PLANS AND DOCUMENTS referred to in the
DEVELOPMENT APPROVAL

Project
PROPOSED INDUSTRIAL
DEVELOPMENT
Address
LOT 118 EASTRIDGE STREET,
STAPYLTON

Drawing title
WATER RETICULATION PLAN

Drawing No
21149/C30

DETAIL 'A'
SCALE 1:50

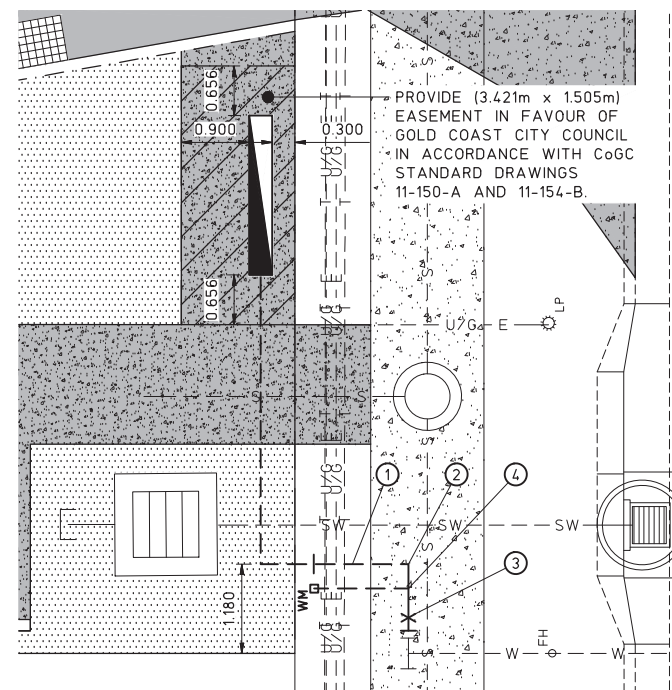
~~GOLD COAST WATER TO
CONSTRUCT NEW DN150
DICL SERVICE AT
DEVELOPERS EXPENSE.~~

~~ALLOW ALL COSTS FOR GOLD COAST
WATER TO INSTALL 150mm COMBINED
FIRE AND SPRINKLER METER IN
ACCORDANCE WITH COUNCIL
STANDARD DRG 11-153B TO SERVICE
DEVELOPMENT. REFER HYDRAULIC
CONSULTANTS DRAWINGS FOR
INTERNAL DETAILS.~~

~~GOLD COAST WATER TO
CONSTRUCT NEW DN32
SERVICE AT DEVELOPERS
EXPENSE.~~

~~ALLOW ALL COSTS FOR GOLD COAST
WATER TO INSTALL DN25 DOMESTIC
METER TO SERVICE DEVELOPMENT.
REFER COUNCIL STANDARD DRG 11-138C
FOR METER DETAILS AND HYDRAULIC
CONSULTANTS DRAWINGS FOR
INTERNAL DETAILS.~~

CONNECTION 1
~~CONNECTION BY GOLD COAST WATER~~
AT DEVELOPERS EXPENSE TO
SERVICE DEVELOPMENT.
1 x DN150 90° DICL BEND
1 x DN150 45° DICL BEND
1 x DN150 DF VALVE
DN150 DICL PIPE CUT TO SUIT
